Access Compliance Report

Public Rights-of-Way

Intersection ID: 10031842	Main Street: MINTWORTH_AV	Cross Street: N/A	Location: SW
ADA ID: 6A4AF56DFEA2	Ramp Type: Perp	Initial Pass/Fail: Fail	Overall Compliance: No
			Severity Score: 25

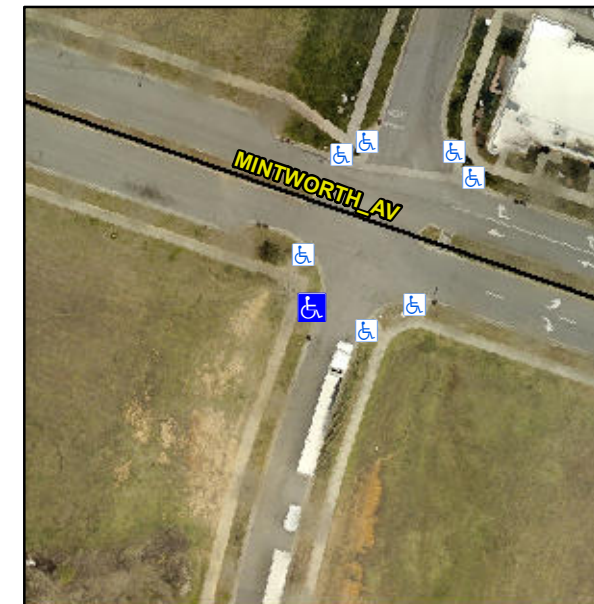
R304.2.2, R304.5.3

Compliance	Description	Data	Compliance	Description	Data
N/A	Ramp Length (in)	101.0	No	Ramp Slope (%)	8.5
Yes	Ramp Width (in)	48.0	No	Ramp XSlope (%)	5.6
N/A	Flare Type LT	N/A	N/A	Flare Type RT	N/A
N/A	Flare Slope LT (%)	N/A	N/A	Flare Slope RT (%)	N/A
N/A	Flare Traversable LT?	N/A	N/A	Flare Traversable RT?	N/A
N/A	Landing Length (in)	N/A	N/A	DWS Provided?	N/A
N/A	Landing Width (in)	N/A	N/A	DWS Contrast?	N/A
N/A	Landing Slope (%)	N/A	N/A	DWS Length (in)	N/A
N/A	Landing X Slope (%)	N/A	N/A	DWS Full Width?	N/A
N/A	Landing Curb? (Y/N)	N/A	N/A	DWS Offset (in)	N/A
N/A	Shared Landing?	N/A			
N/A	Gutter Ponding?	N/A	N/A	Gutter Slope (%)	N/A
N/A	Gutter Lip Ht (in)	N/A	N/A	Gutter X Slope (%)	N/A
N/A	Painted X Walk1?	No	N/A	Painted X Walk2?	N/A
	X Walk 1 Direction	To SE		X Walk 2 Direction	N/A
N/A	X Walk 1 Width (in)	N/A	N/A	X Walk 2 Width (in)	N/A
	X Walk 1 Slope (%)	4.8		X Walk 2 Slope (%)	N/A
	X Walk 1 X Slope (%)	2.6		X Walk 2 X Slope (%)	N/A

Remove & Replace Entire Ramp.
